Docket Nos. 50-325
and 50-324

The Commission has issued the enclosed Amendment No. 23 to Facility Operating License No. DPR-71 and Amendment No. 47 to Facility Operating License No. DPR-62 for the Brunswick Steam Electric Plant (BSEP), Unit Nos. 1 and 2, respectively. These amendments consist of changes to the operating licenses and Technical Specifications in response to your applications dated December 29, 1978, February 19, 1979, and March 6, 1979. The December 29, 1978 reload license application was supplemented by letters dated January 17, 1979, March 16 and March 27, 1979. The March 6, 1979 fire protection application was supplemented by letters dated March 7, March 15, March 22, and March 29, 1979.

UNITED STATES
NUCLEAR REGULATORY COMMISSION
WASHINGTON, D. C. 20555

SUPPLEMENT NO. 1
TO THE
FIRE PROTECTION
SAFETY EVALUATION REPORT
BY THE
OFFICE OF NUCLEAR REACTOR REGULATION
U.S. NUCLEAR REGULATORY COMMISSION
IN THE MATTER OF
CAROLINA POWER & LIGHT COMPANY
BRUNSWICK STEAM ELECTRIC PLANT
UNIT NOS. 1 and 2
DOCKET NOS. 50-325 and 50-324

Figure 3.2.1-1

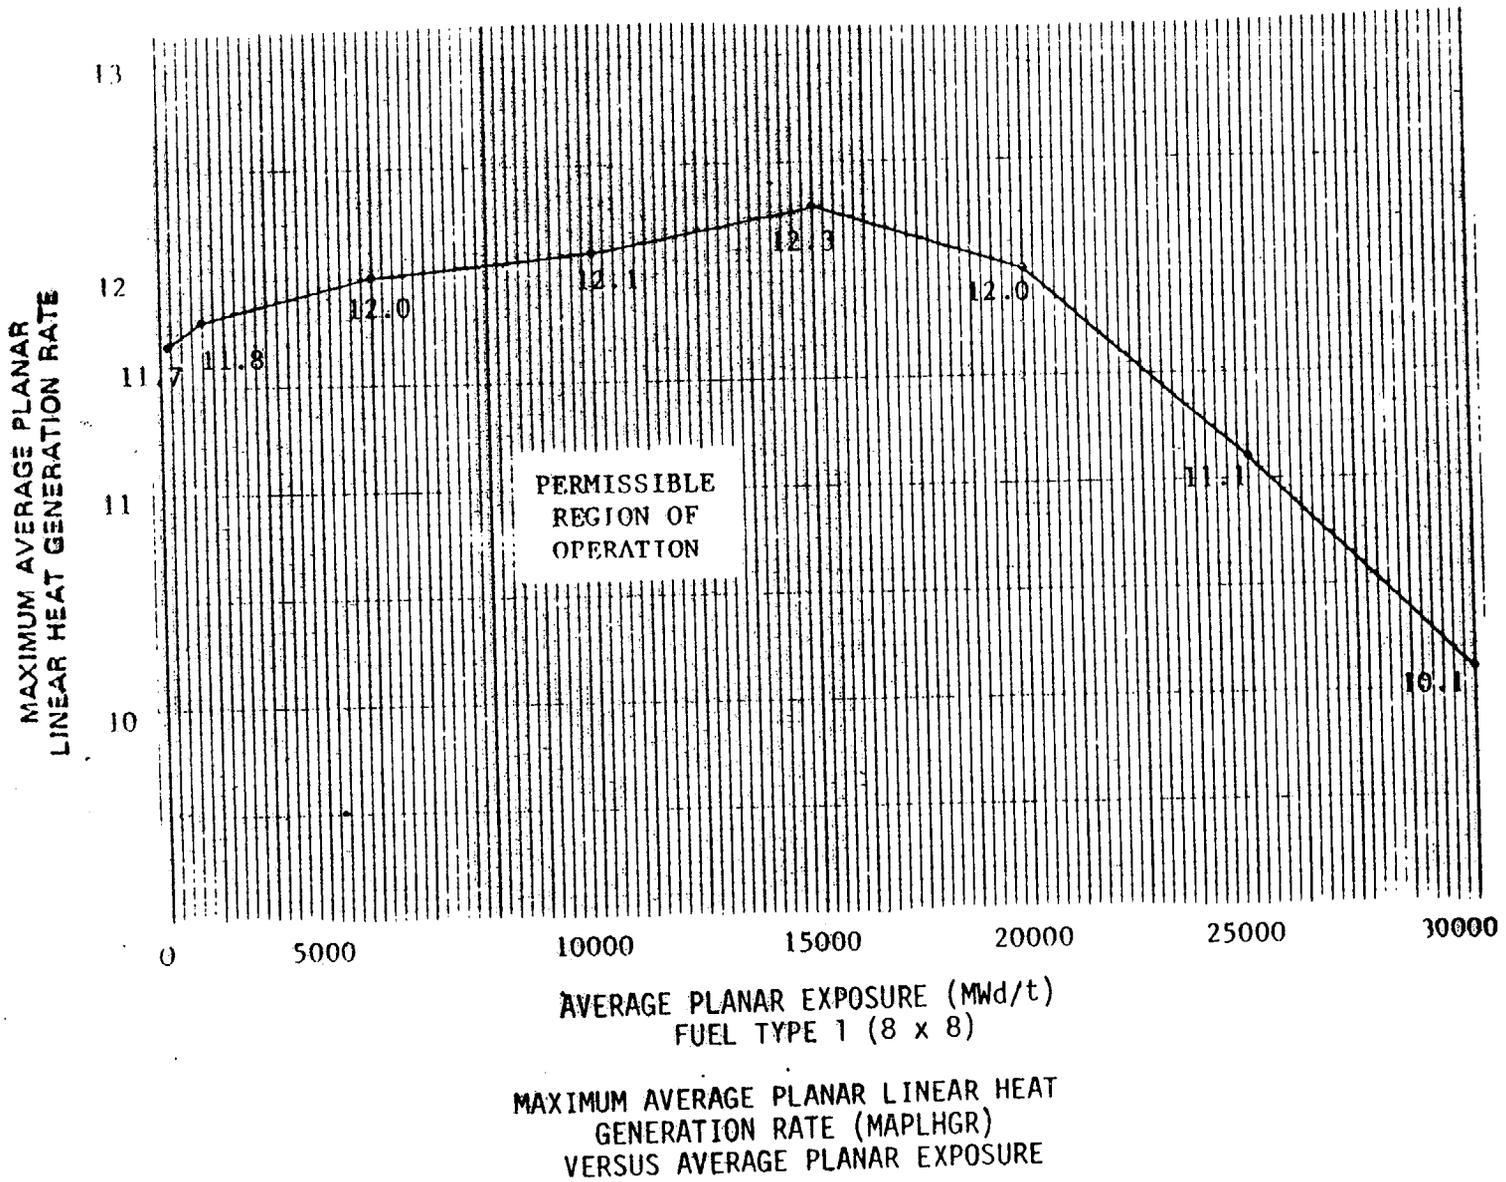
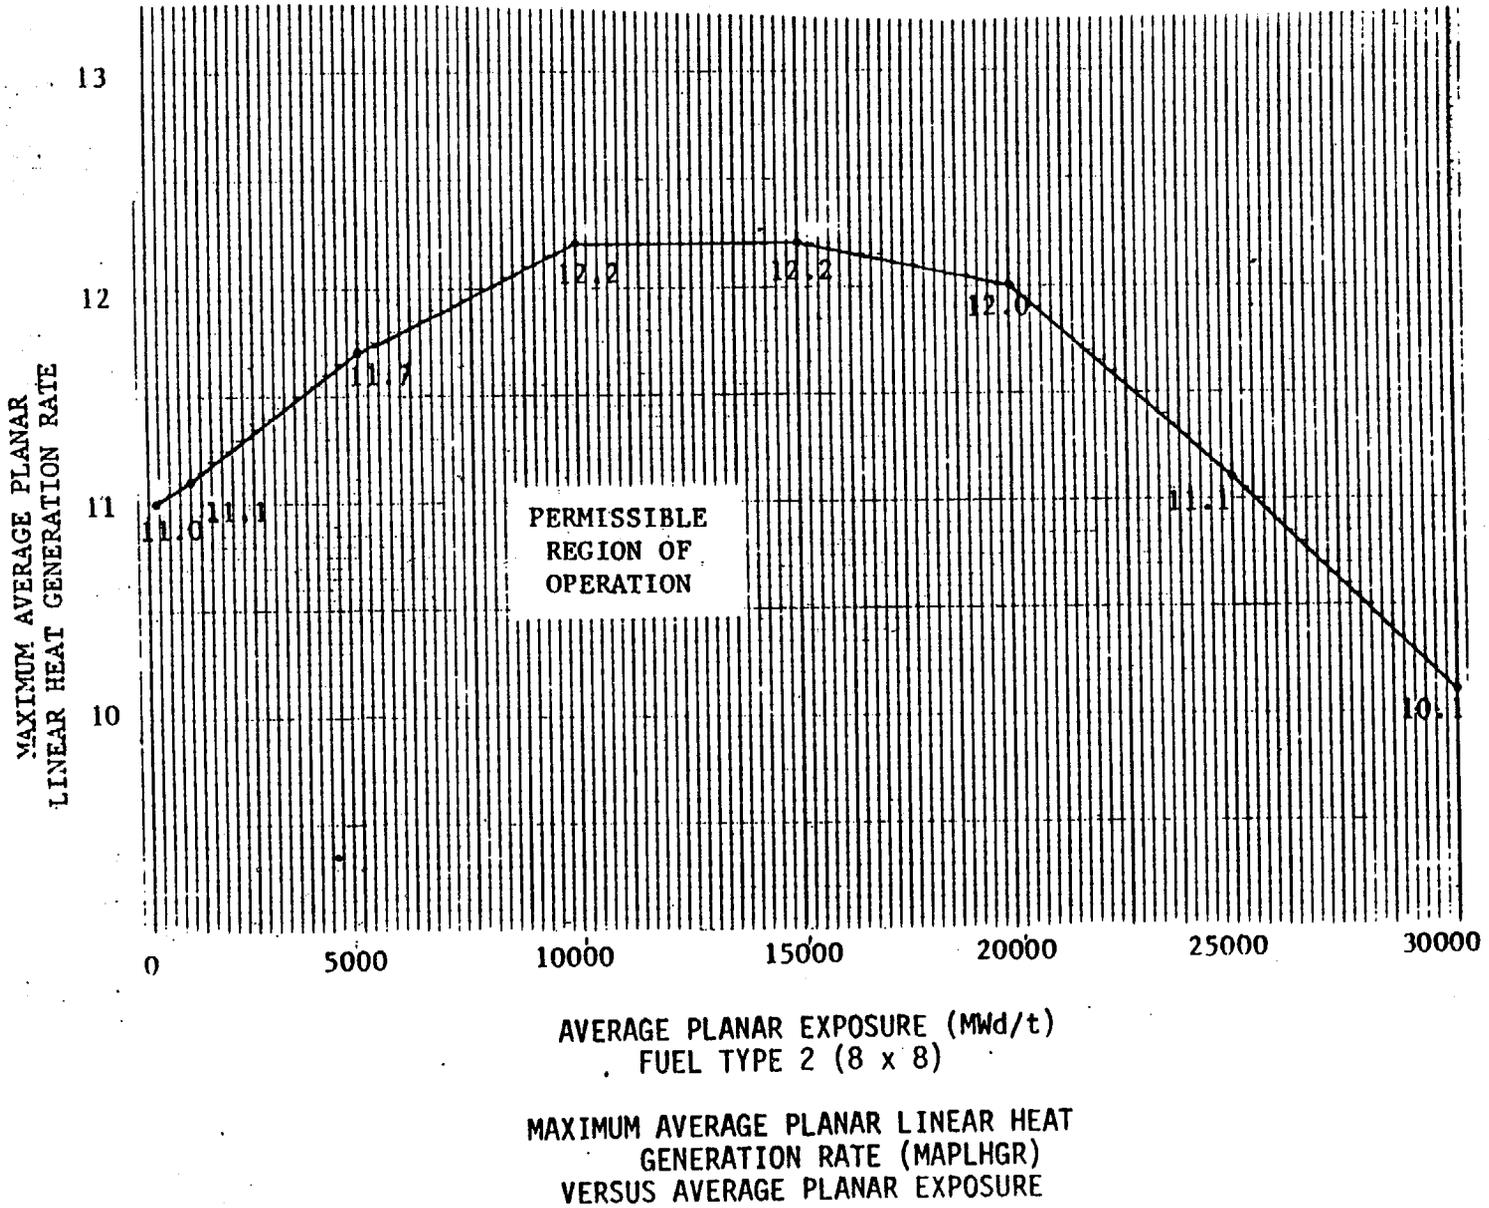
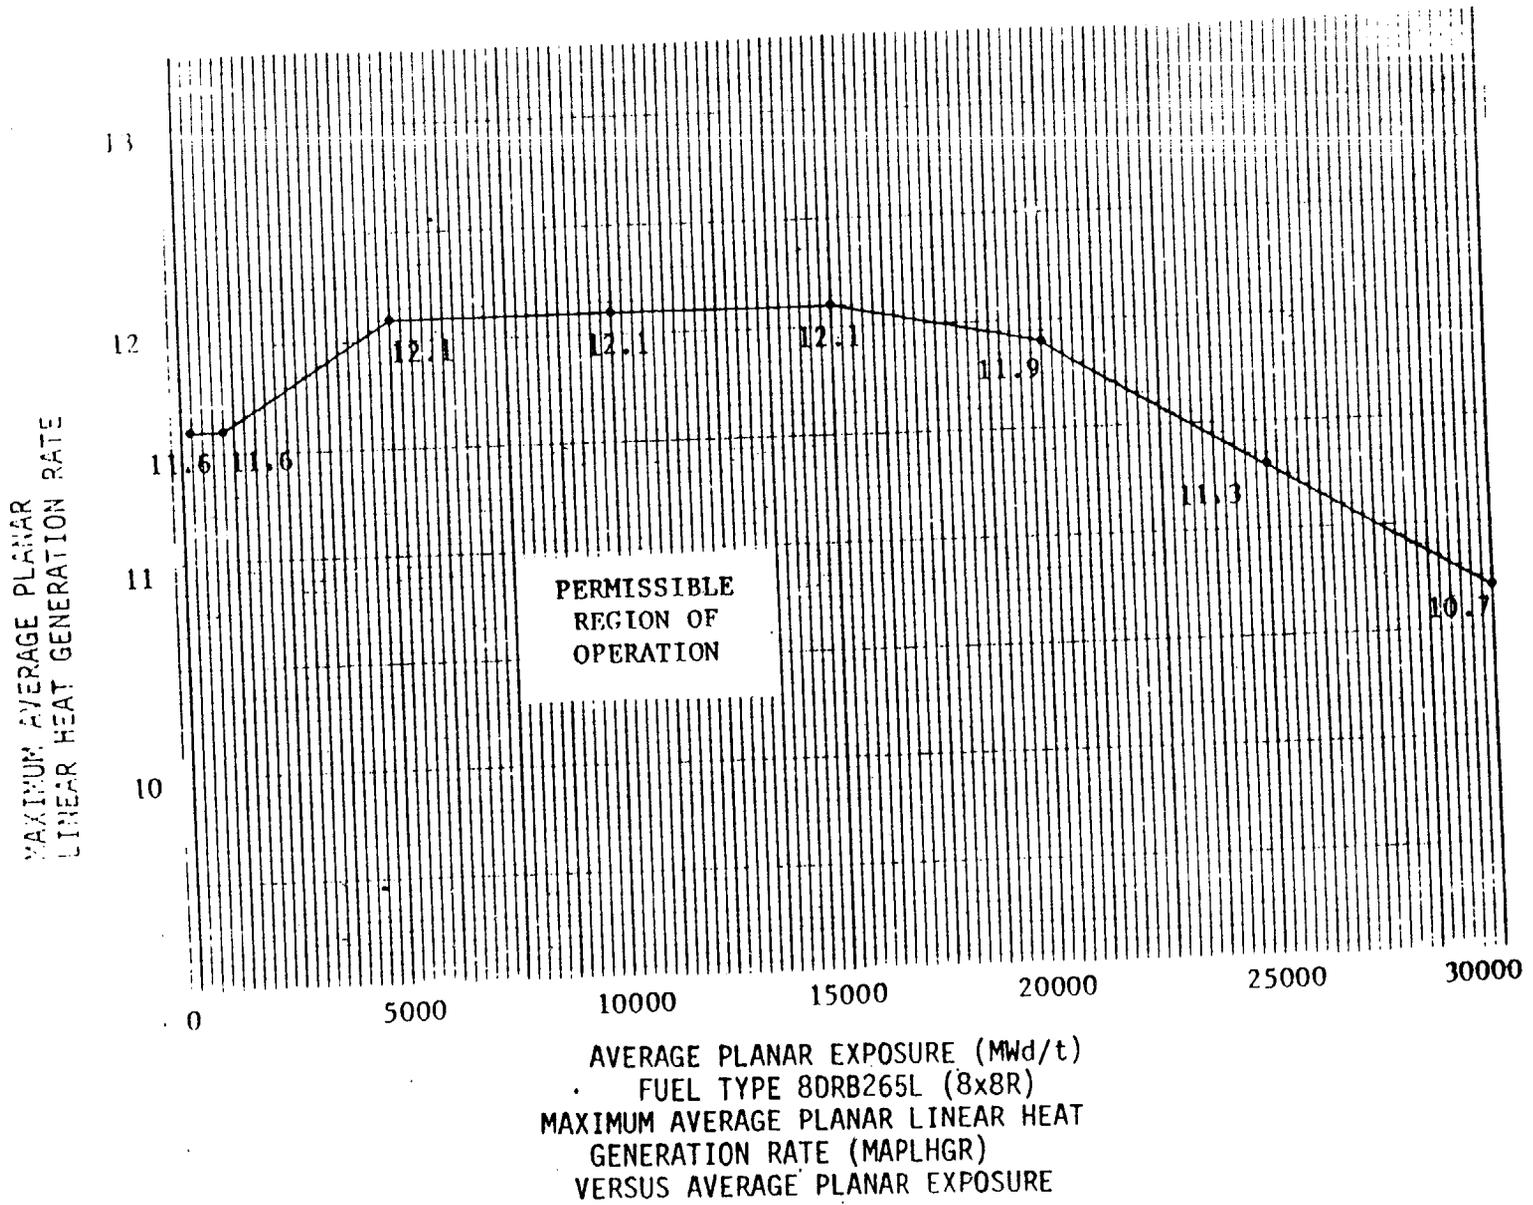
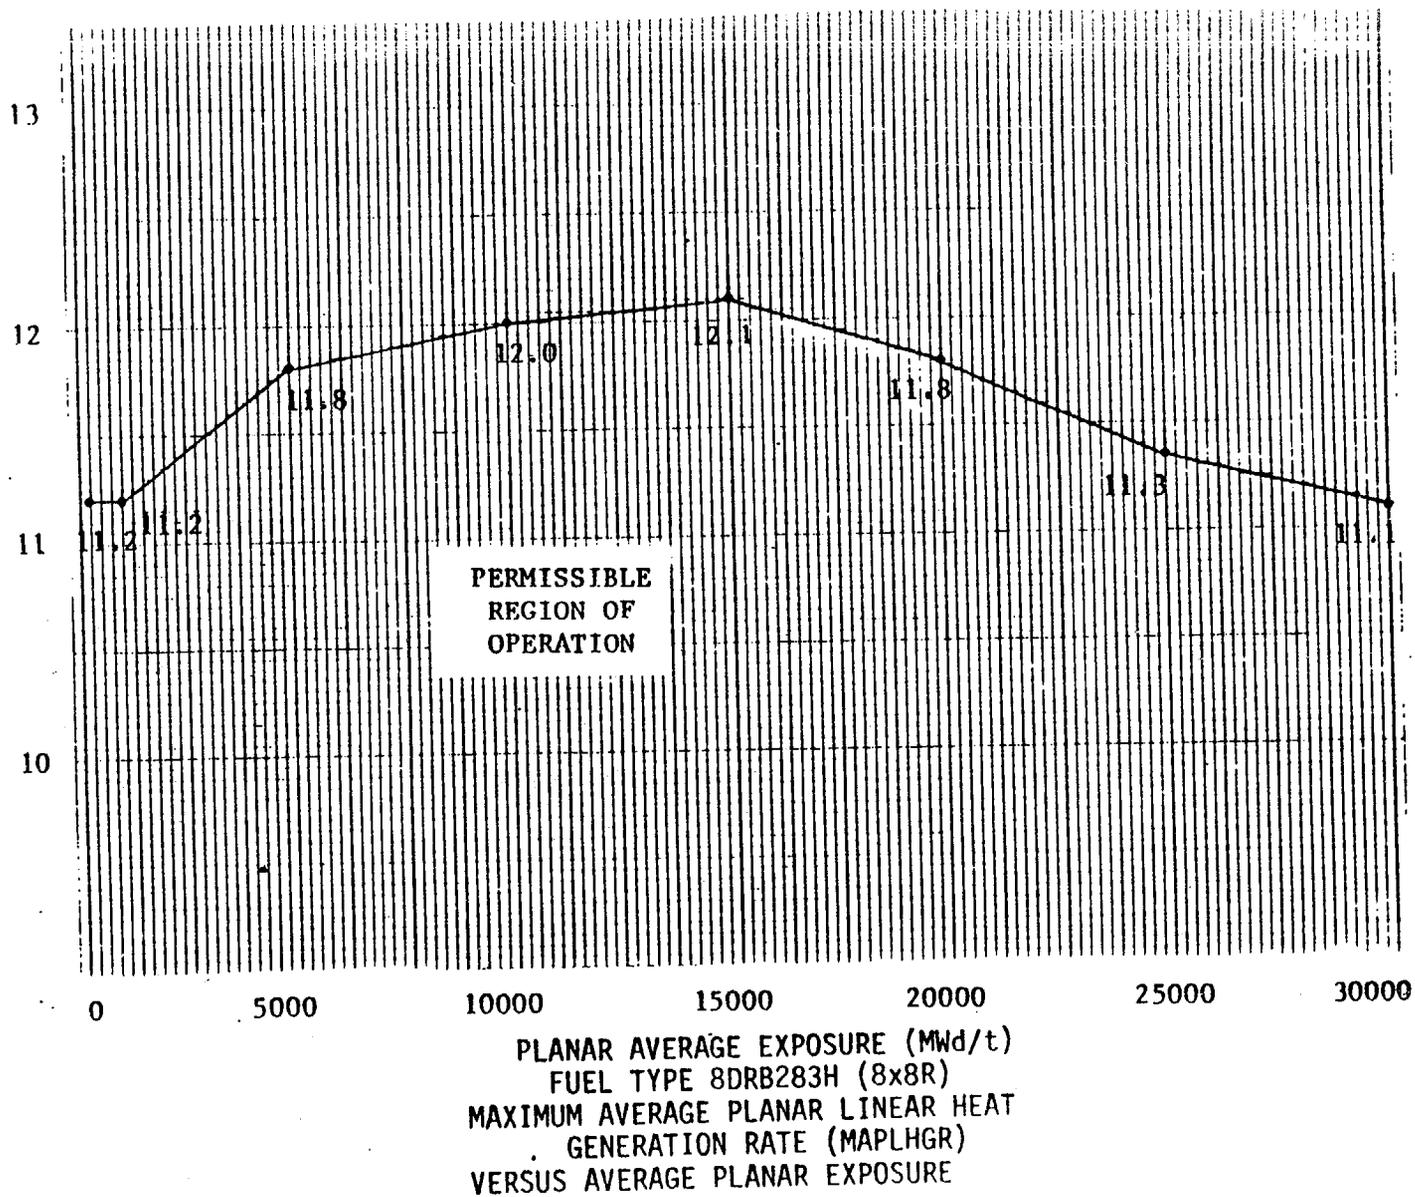
3.2.1 All AVERAGE PLANAR LINEAR HEAT GENERATION RATES (APLHGR's) for each type of fuel as a function of AVERAGE PLANAR EXPOSURE shall not exceed the limits shown in Figures 3.2.1-1, 3.2.1-2, 3.2.1-3, or 3.2.1-4.

The calculational procedure used to establish the APLHGR shown on Figure 3.2.1-1 thru 3.2.1-4 is based on a loss-of-coolant accident analysis. The analysis was performed using General Electric (GE) calculational models which are consistent with the requirements of Appendix K to 10 CFR 50. A complete discussion of each code employed in the analysis is presented in Reference 1. Differences in this analysis compared to previous analyses performed with Reference 1 are: (1) The analyses assumes a fuel assembly planar power consistent with 102% of the MAPLHGR shown in Figures 3.2.1-1, and 3.2.1-2; (2) Fission product decay is computed assuming an energy release rate of 200 MEV/Fission; (3) Pool boiling is assumed after nucleate boiling is lost during the flow stagnation period; (4) The effects of core spray entrainment and counter-current flow limitation as described in Reference 2, are included in the reflooding calculations.

K_f FACTOR
 FIGURE 3.2.3-1

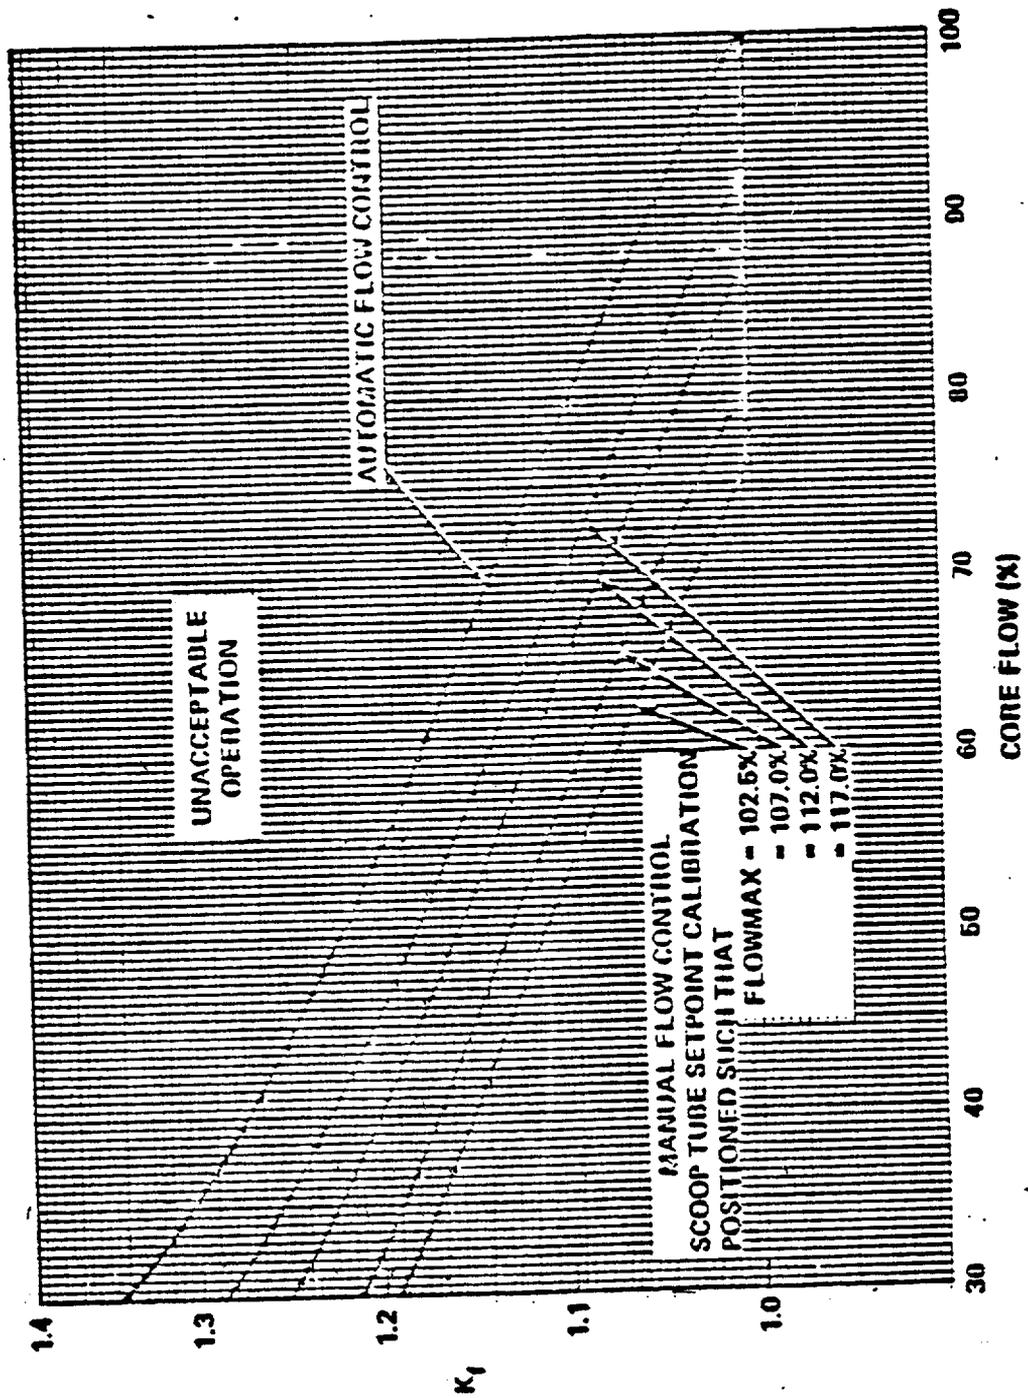
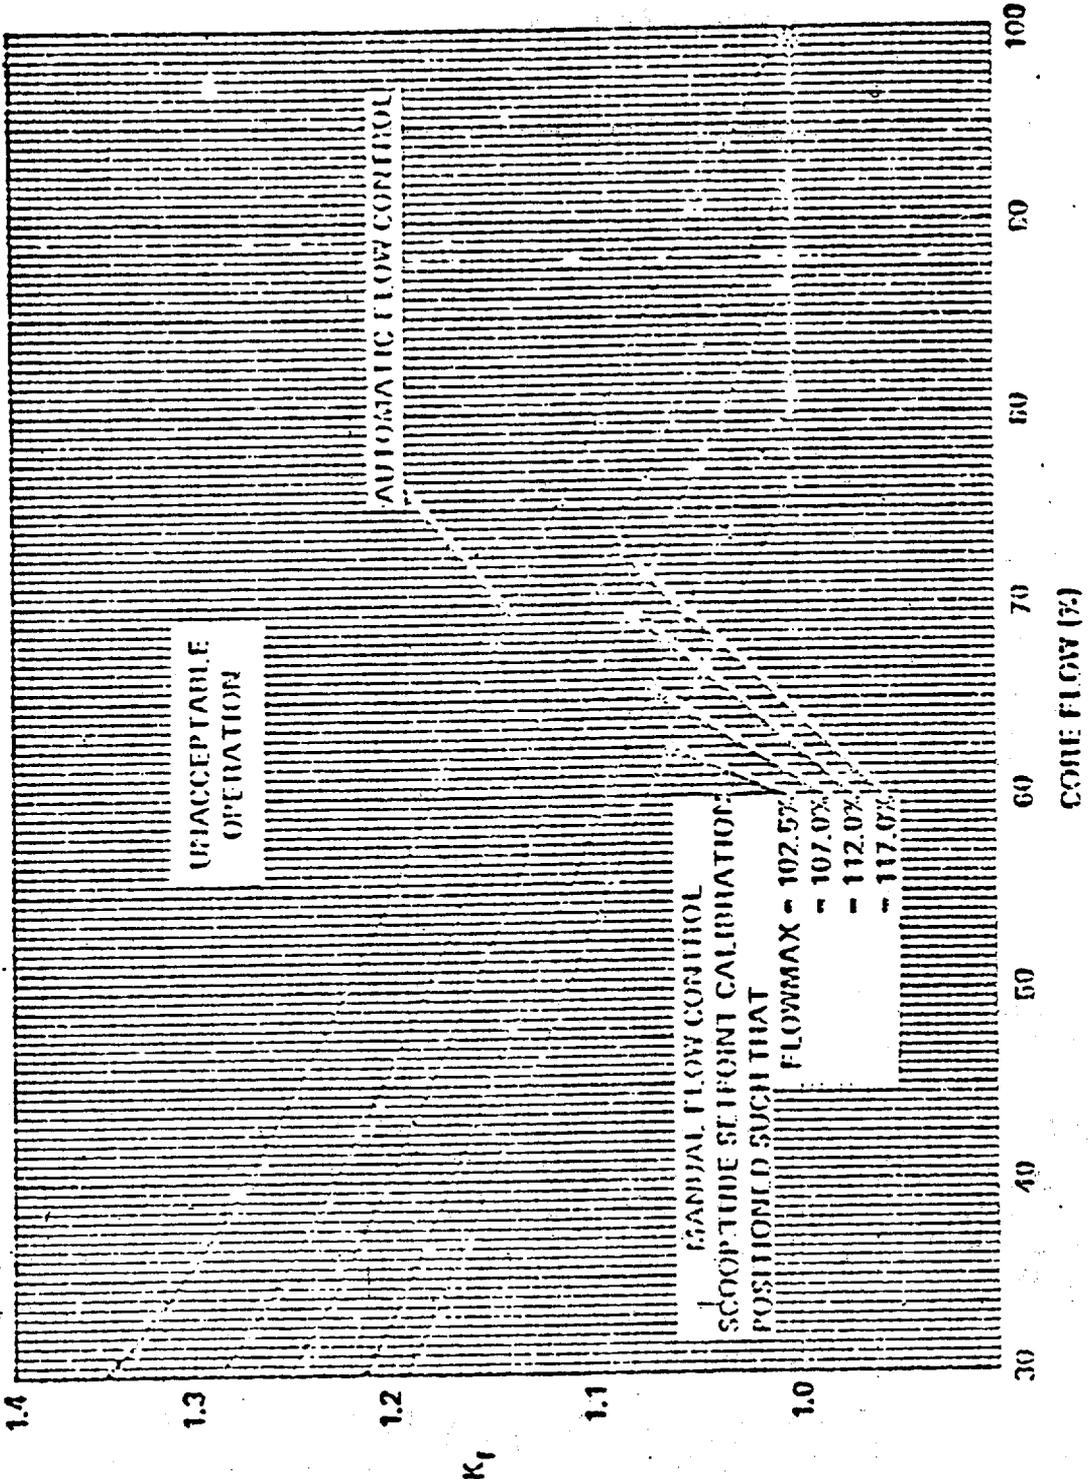
3.2.3 The MINIMUM CRITICAL POWER RATIO (MCPR), as a function of core flow, shall be equal to or greater than MCPR x the K_f shown in Figure 3.2.3-1 where:

The K_f factor values shown in Figure 3.2.3-1 were developed generically which are applicable to all BWR/2, BWR/3, and BWR/4 reactors. The K_f factors were derived using the flow control line corresponding to rated thermal power at rated core flow.

The K_f factors shown in Figure 3.2.3-1 are conservative for the General Electric Plant operation because the operating limit MCPR's of Specification 3.2.3 are greater than the original 1.20 operating limit MCPR used for the generic derivation of K_f .
